APPENDIX V: Valve Placement, Orientation and Location

Pic: 0402x

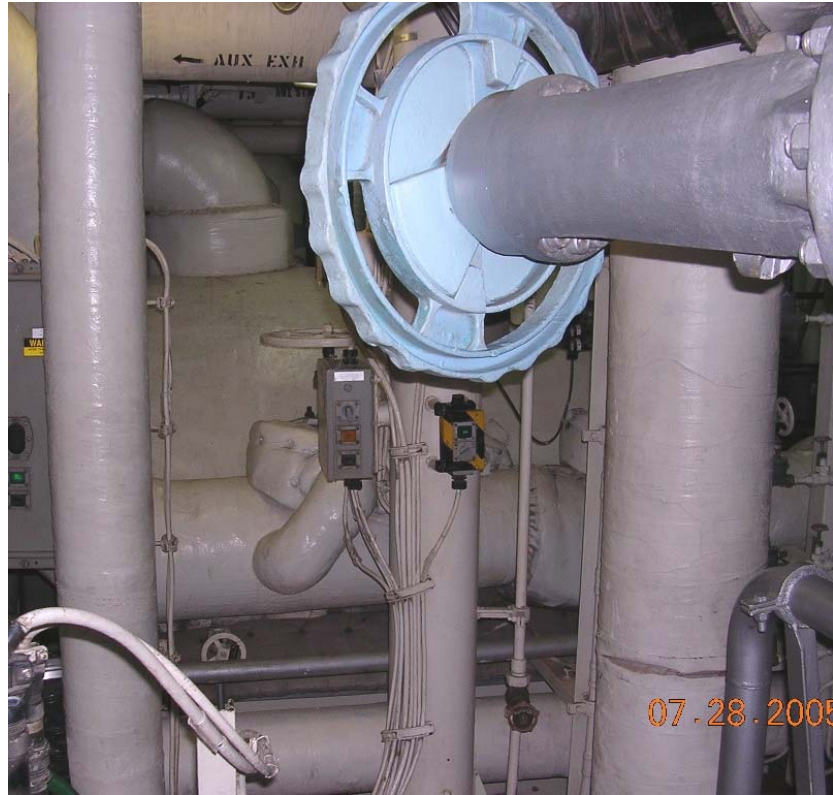
1. Valve handwheel protrudes into passageway.
2. The height of the handwheel above deck exceeds the optimal limit for valve operation.

1. Relocate valve handwheel such that it doesn't protrude into passageway.
2. Relocate valve handwheel within human performance envelope which is lower than currently positioned, less than 72" off the deck surface.

Pic: 0116x

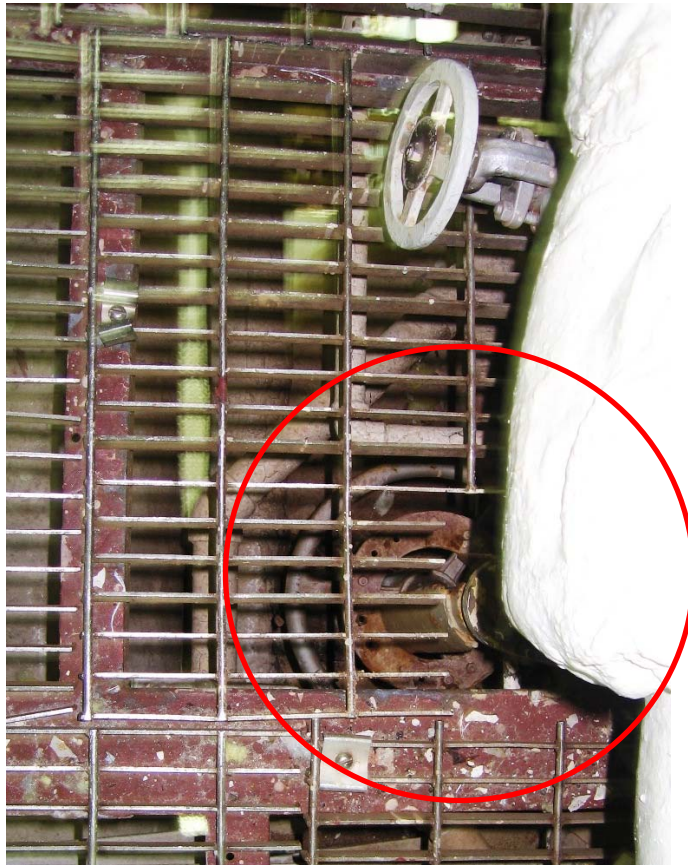
Valve located under grating is difficult to access.

1. Cut back grating in order to access the front of valve handwheels.
2. Valves that are required to be used in emergency situations (determined by a valve criticality assessment) should not be located below the grating.
3. Provide at least 3" of clearance on all sides of handwheel.

Pics: 0421x, 0422x

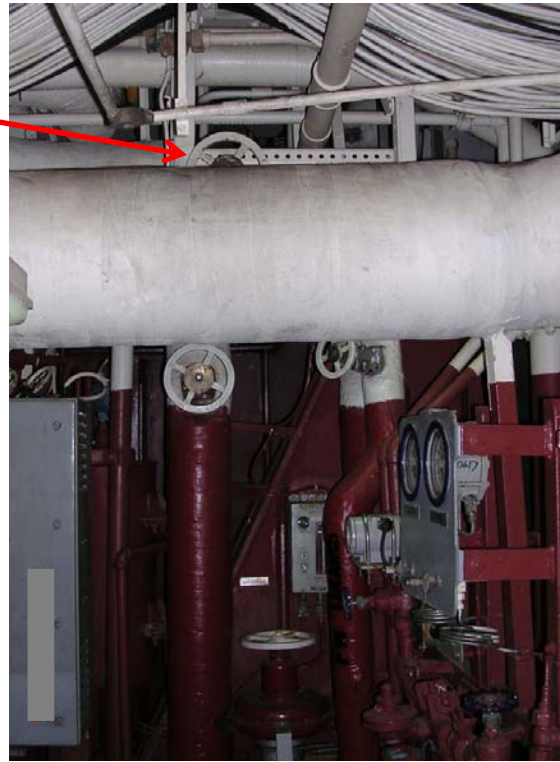
Location and position of valve handwheel requires the operator to step on a structure not intended for standing and reach over a pipe that may be hot.

1. Change the piping layout to lower the valve handwheel location so as not to encourage unsafe behavior of personnel by standing on equipment to access valves.
2. Add a small platform so as to provide a safe standing surface, if necessary.

Pic: 0411x

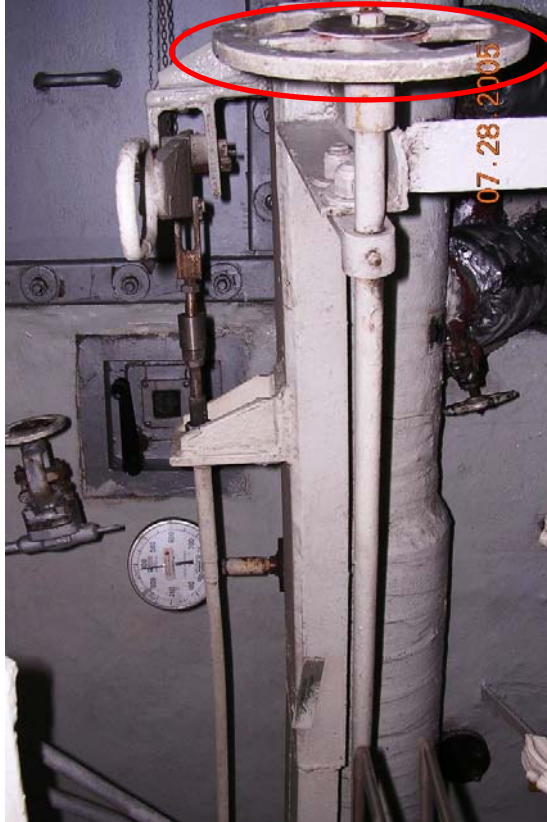
1. The vertical stem handwheel is above the level for normal operation by personnel from the top.
2. The gauge display is oriented more than 90 degrees from upright which makes it difficult to read accurately.

1. Relocate valve handwheel to an appropriate height for operation from the top, which should be below 51" off the standing surface.
2. Rotate the gauge 90 degrees in order to be read upright.
